Community Solar Project Interconnection  
**Community Solar Project System Impact Study Report**

**(“Applicant”)**  
**OCS001**

Proposed Point of Interconnection  
**Circuit 5D69 out of Prineville substation near 44°17’4.24”N,  
120°53’18.28”W**

**May 13, 2020**

Figure 2: System One Line Diagram

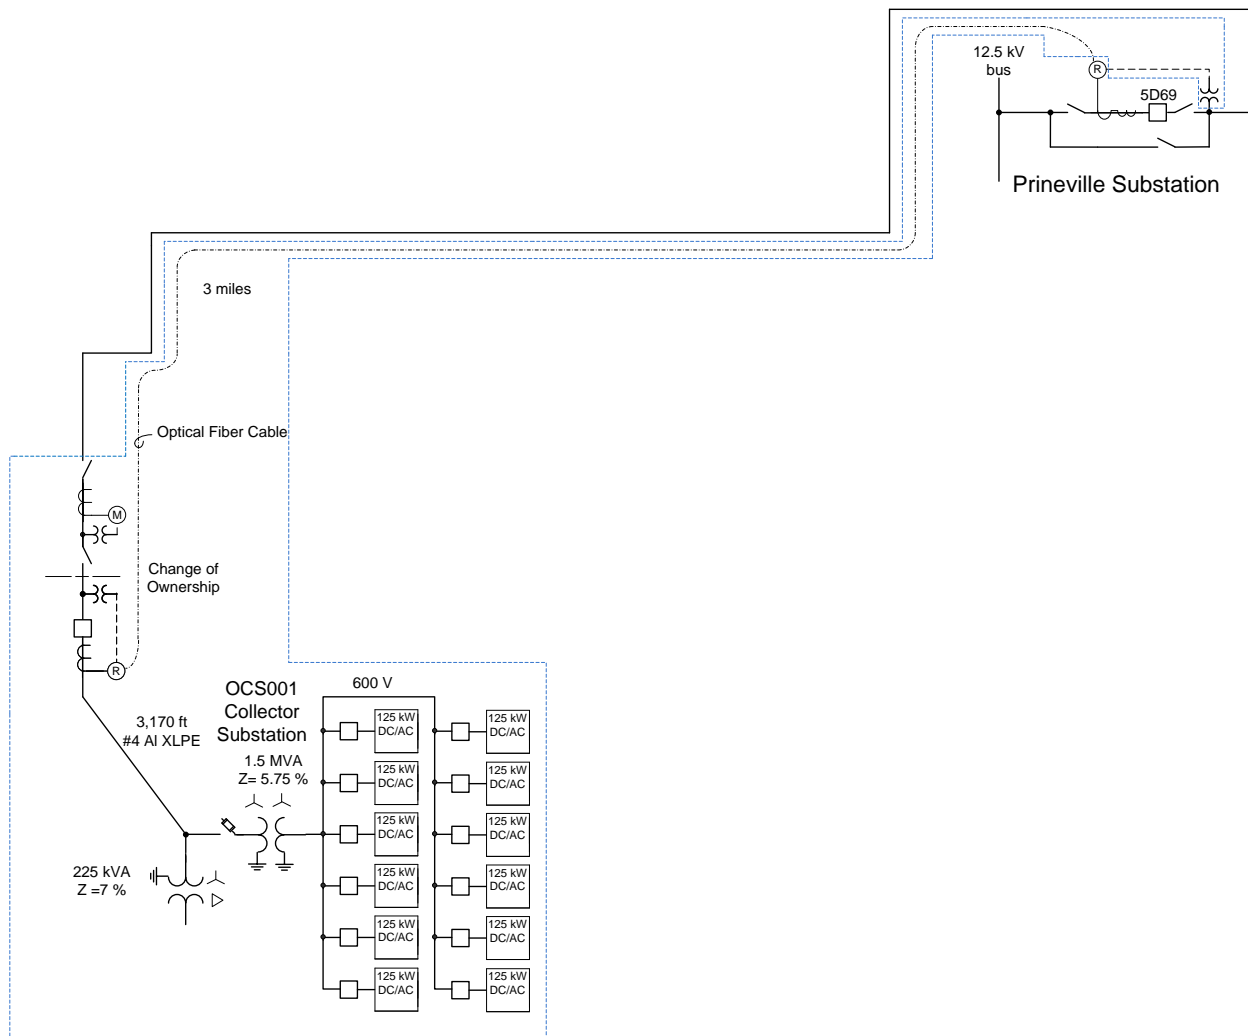
system until the generation disconnects. The proposed wye – wye step-up transformer will not accomplish the stabilization of the phase to neutral voltages on the 12.5 kV system. The circuit that the project is connecting to is a four wire multi-grounded circuit with line to neutral connected load. Figure 2 shows the addition of a wye – delta grounding transformer of adequate power size and impedance that will meet the requirement.
